Mack Trucks, Inc.
Greensboro, NC USA

SR-10051928-1748
Service Program
Trucks

Incorrect Hardware on Front Engine Mount
MRU

PI0821, Incorrect Hardware on Front Engine Mount

MRU, Engine Mount Installation (Mack Engines)

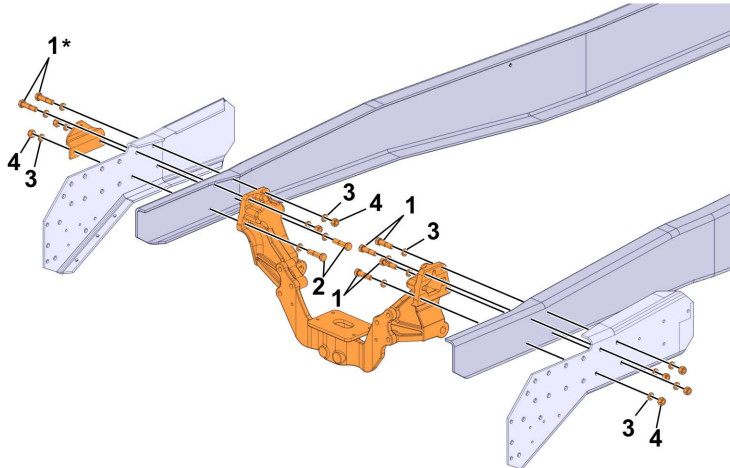
Certain MRU vehicles may have been assembled using the incorrect grade and/or length of bolts in the front engine mount for both the left and right side of the vehicle. Bolt part numbers and length vary depending on the engine model installed on the vehicle. To complete the repair and install the proper bolts, utilize the installation drawings and part number lists included in this document.

Description	Part Number	Quantity	Illustration Number
Shoulder Bolt	25087900	6	1
Shoulder Bolt	25012714	2	2
Washer	25088675	14	3
Hexagon Nut	20760812	8	4

Note: * Bolt head located outside of the frame. All other bolt heads located inside of the frame.
